ADDENDUM NO. CC-2

STATE OF NEBRASKA  
TSB – EXTERIOR RENOVATION  
LINCOLN, NEBRASKA  
DLR GROUP PROJECT NO. 10-09206-30

September 13, 2012

NOTICE TO BIDDERS: Amend the Project Manual and Drawings to the above referenced project as follows:

1  
A10.1 ARCH LINTEL ELEVATION  
SCALE: 1/4" = 1'-0"

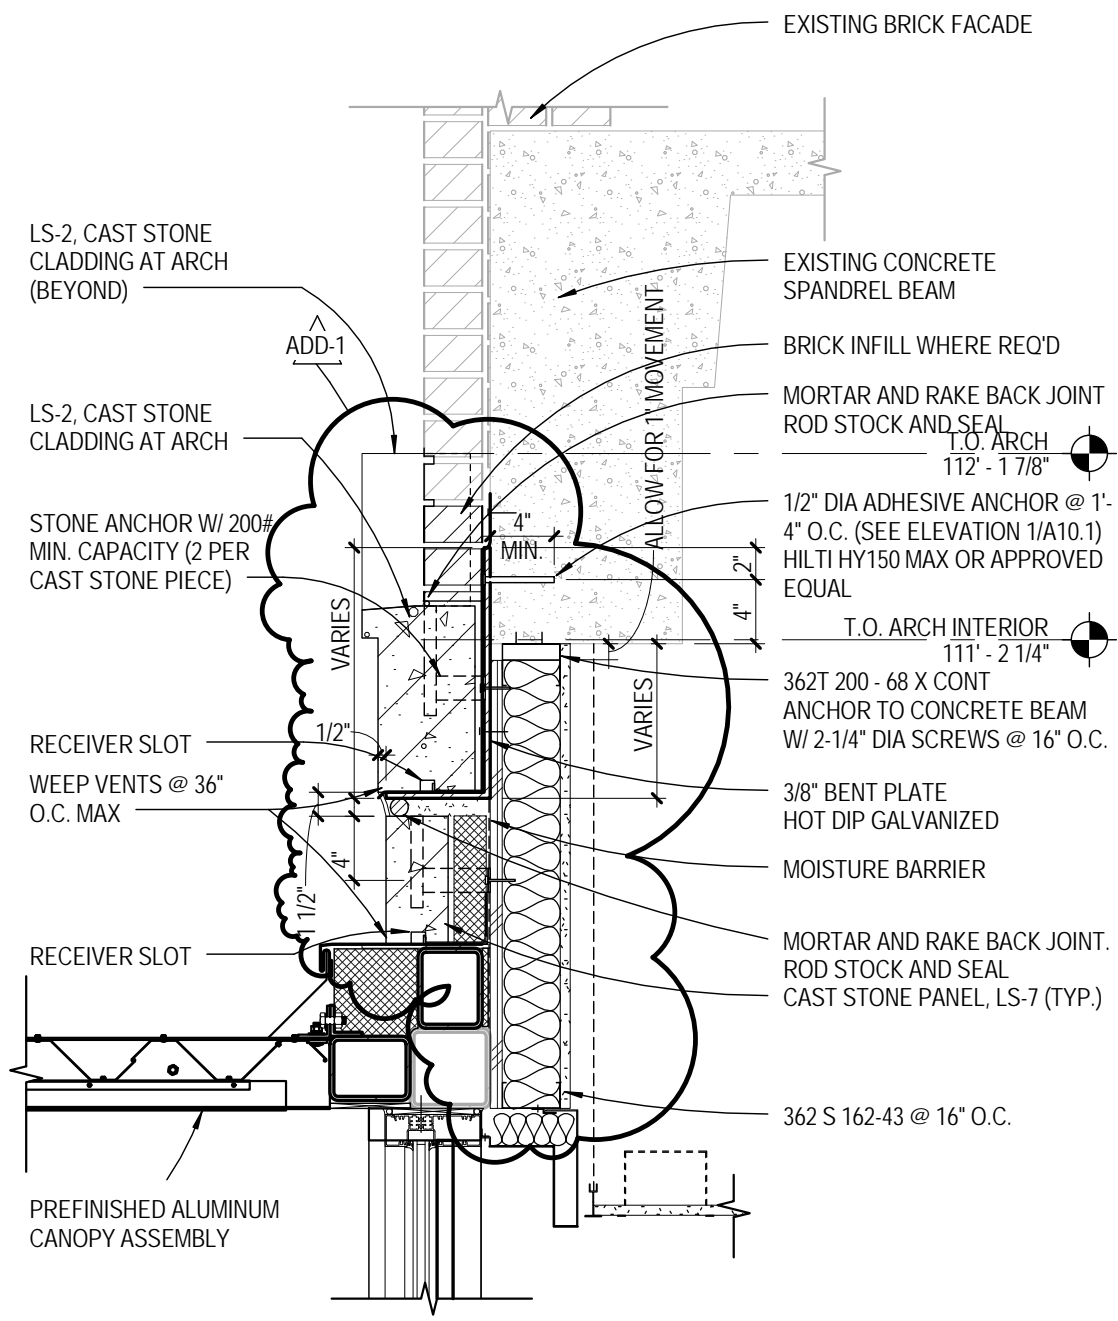
#### ITEM NO. 1 DRAWING 21/A7.2 STORE FRONT

- A. Section – M Street Store Front. Modify all arched openings as shown on Attachment A10.1.

1 ARCH END SECTION  
 A10.2 SCALE: 1" = 1'-0"

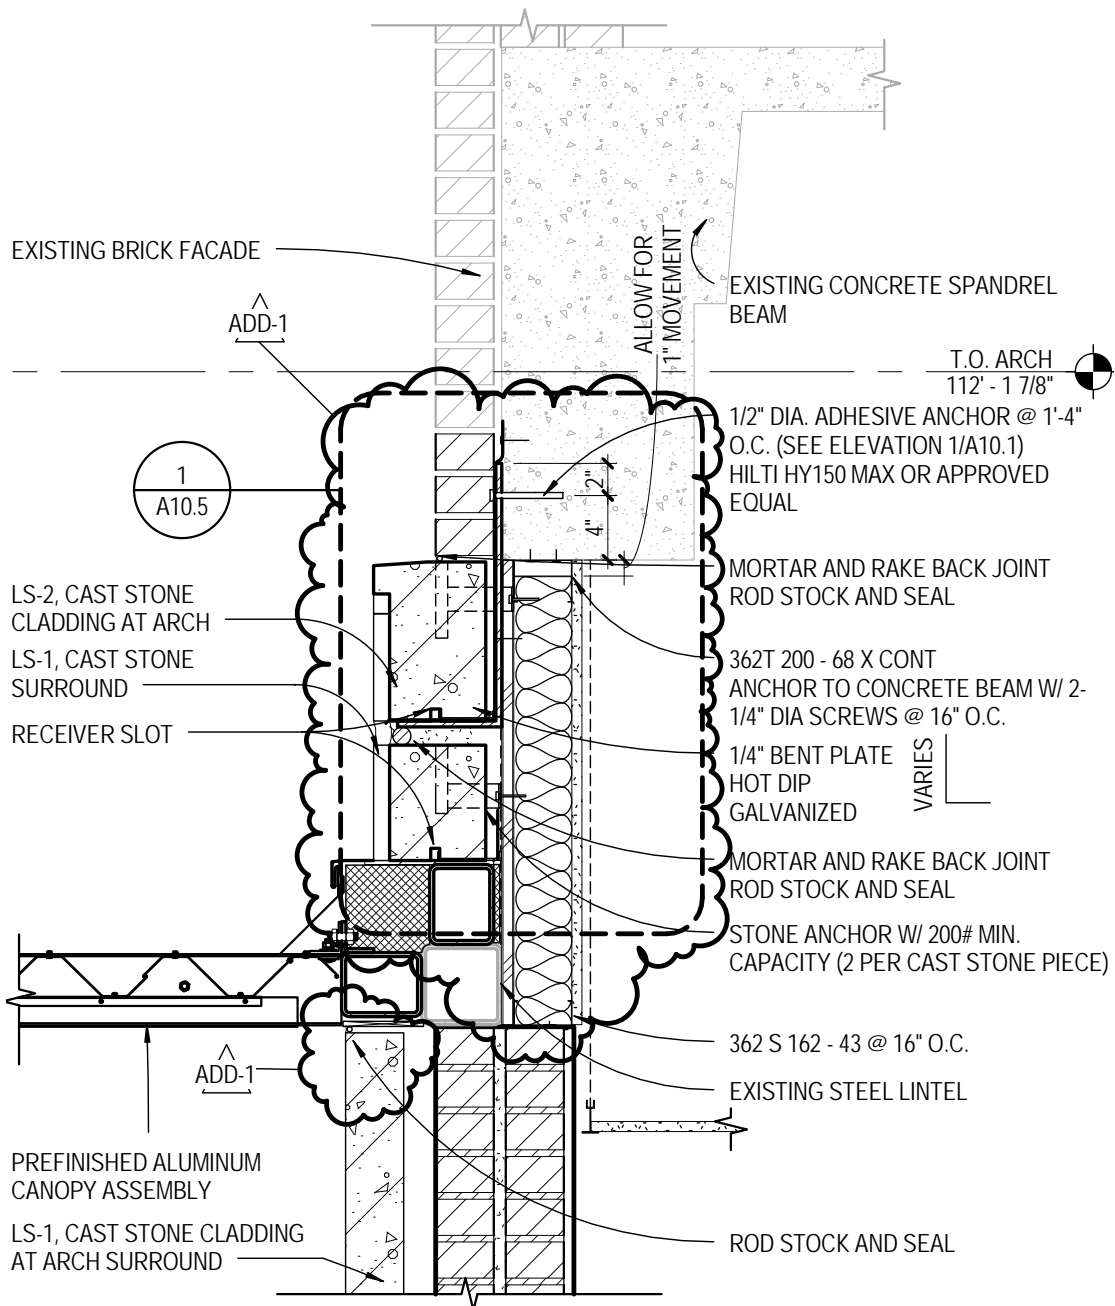
#### ITEM NO. 2 DRAWING 34/A7.3 WALL SECTIONS AND BUILDING DETAILS

- A. Modify drawing as shown on Attachments A10.2, A10.3, A10.4 and A10.5.

1 DETAIL AT STOREFRONT SILL (TYP.)  
A10.6 SCALE: 1 1/2" = 1'-0"

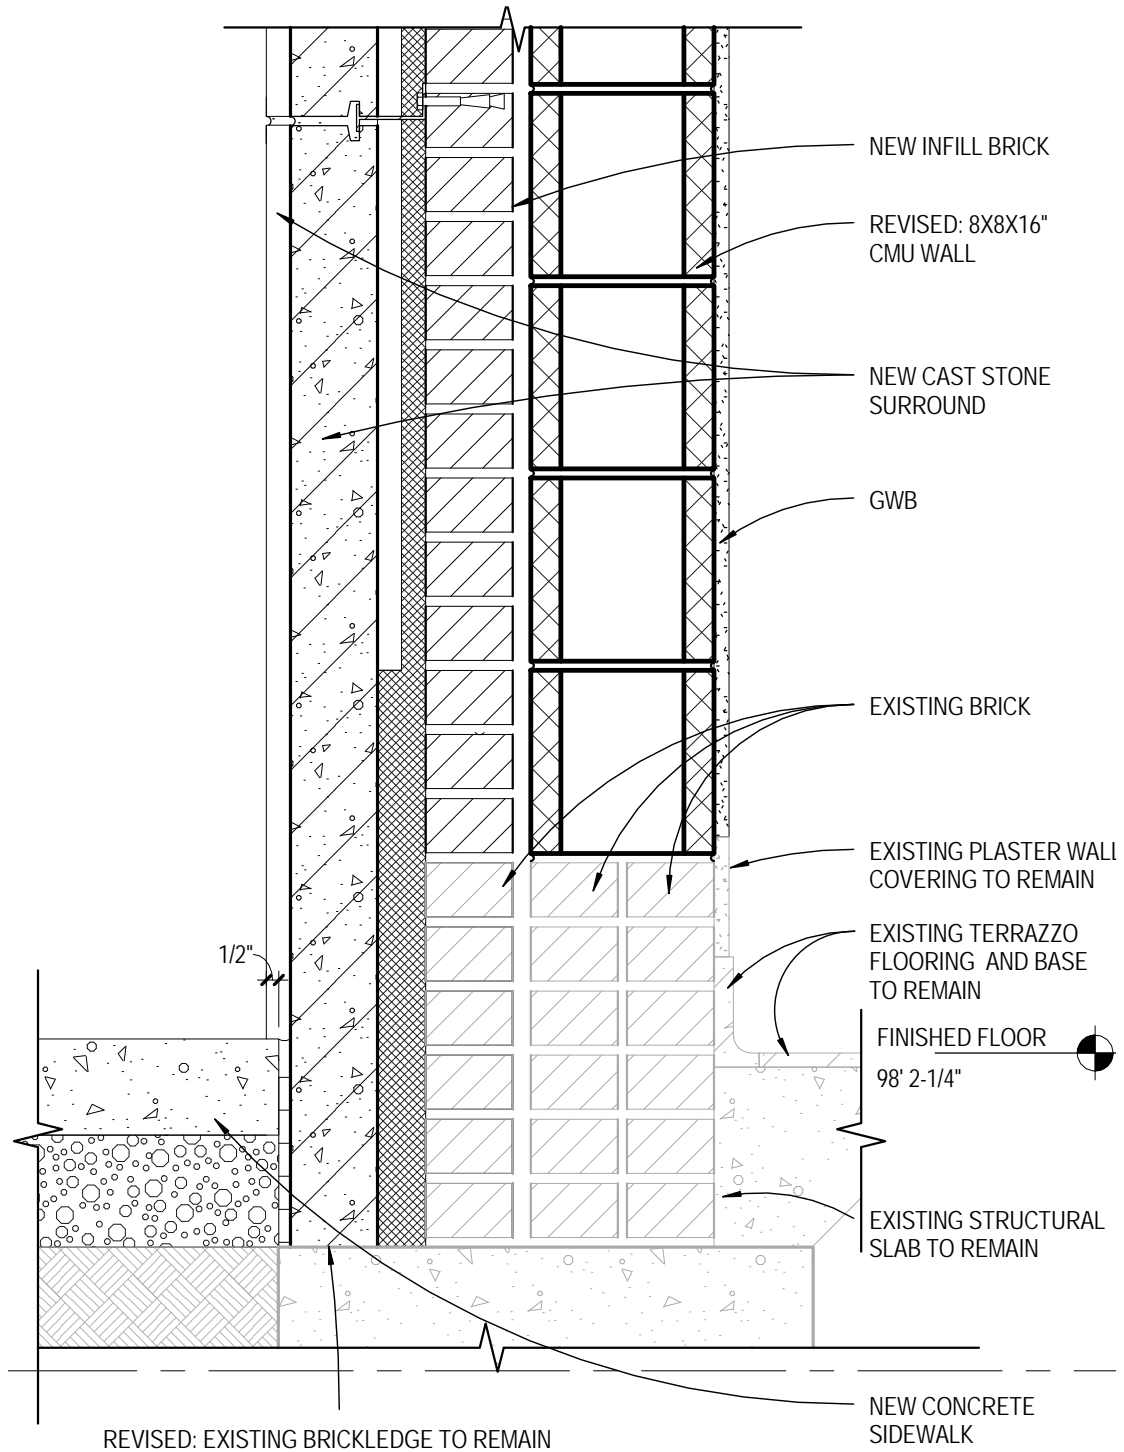
ITEM NO. 3 DRAWING 54/A7.3 - DETAIL AT STORE FRONT SILL (TYP.)

A. Modify drawing as shown on A10.6.

Attachment No. 8  
to ADDENDUM CC-2  
Dated: 9/13/2012

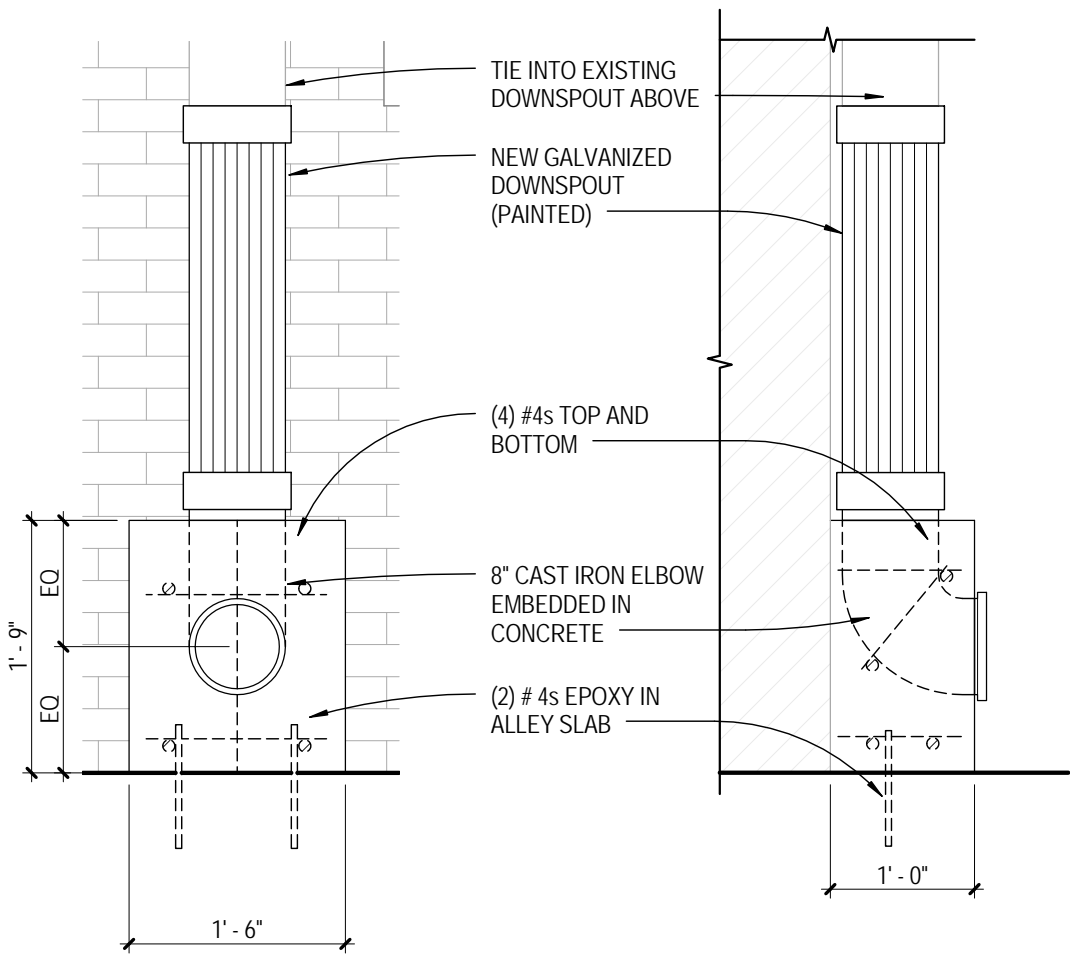
ITEM NO. 5 DRAWING A.73 - WALL SECTIONS AND BUILDING DETAILS

A. Add Drawing A10.8, Attachment 8 BALLARD DETAIL in its entirety.

- GUARD POST LOCATIONS:
1. GUARD POST SHALL CLEAR DOOR OPENINGS BY ALIGNING FACE OF POST WITH DOOR OPENING
  2. GUARD POST FOOTING SHALL CLEAR FOOTINGS BY 2-INCHES MINIMUM

1 DOWNSPOUT DETAIL  
 A10.9 SCALE: 3/4" = 1'-0"

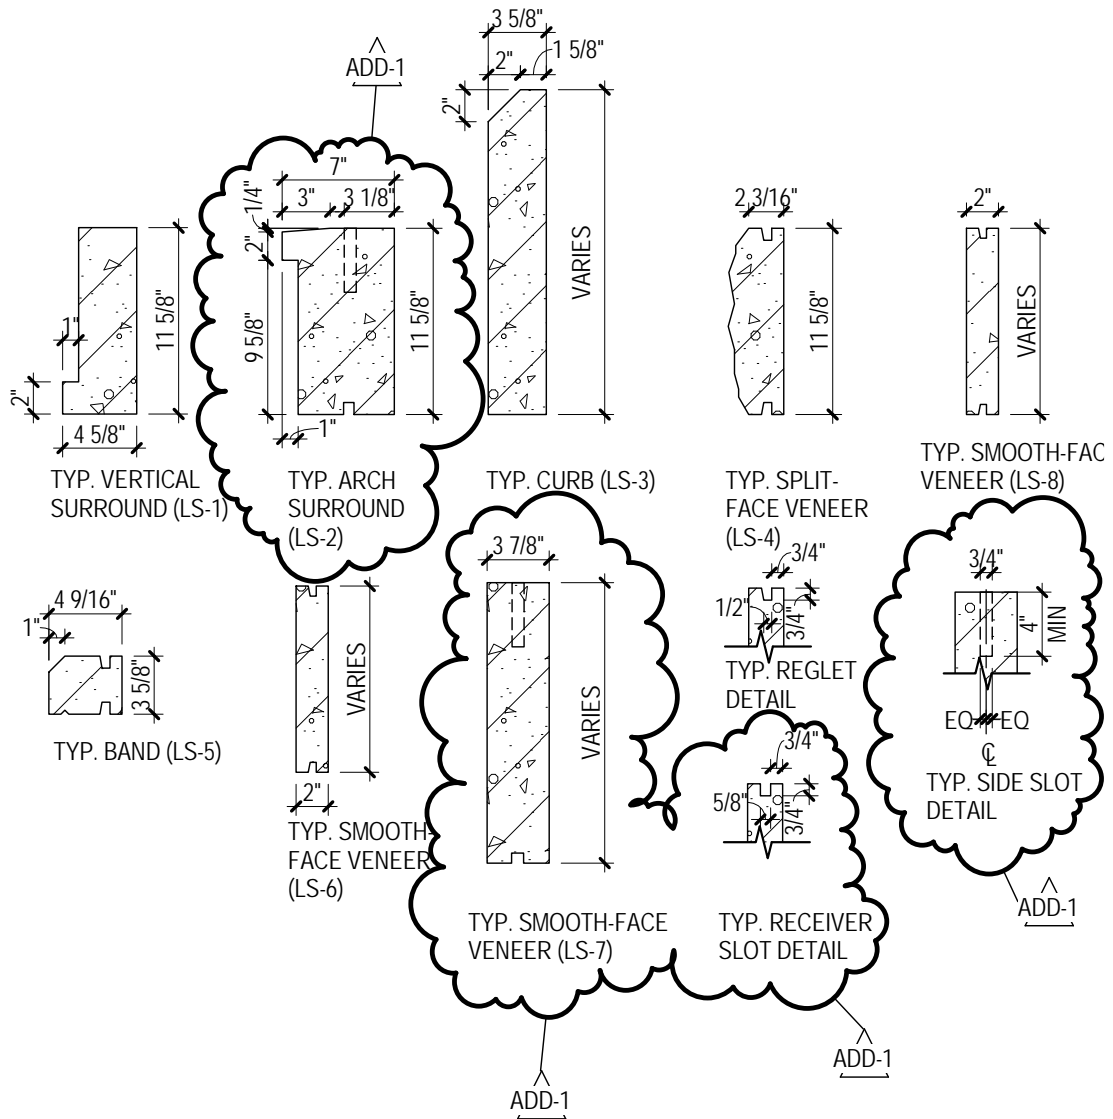
ITEM NO. 6 DRAWING A10.9 – NORTH FACADE DOWNSPOUT DETAIL

A. Add Drawing A10.9, Attachment No. 9 to the documents.

Attachment No. 10  
to ADDENDUM CC-2  
Dated: 9/13/2012

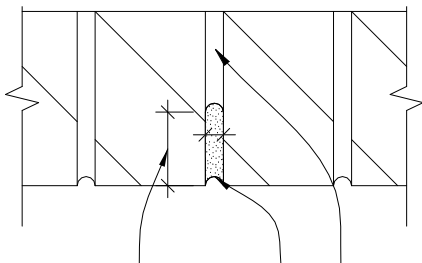
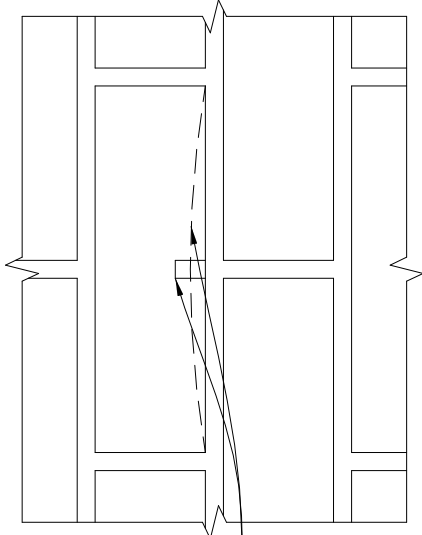
ITEM NO. 7 DRAWING 21/A7.4 - CAST STONE PROFILES

A. Modify drawing as shown on Attachment A10.10.
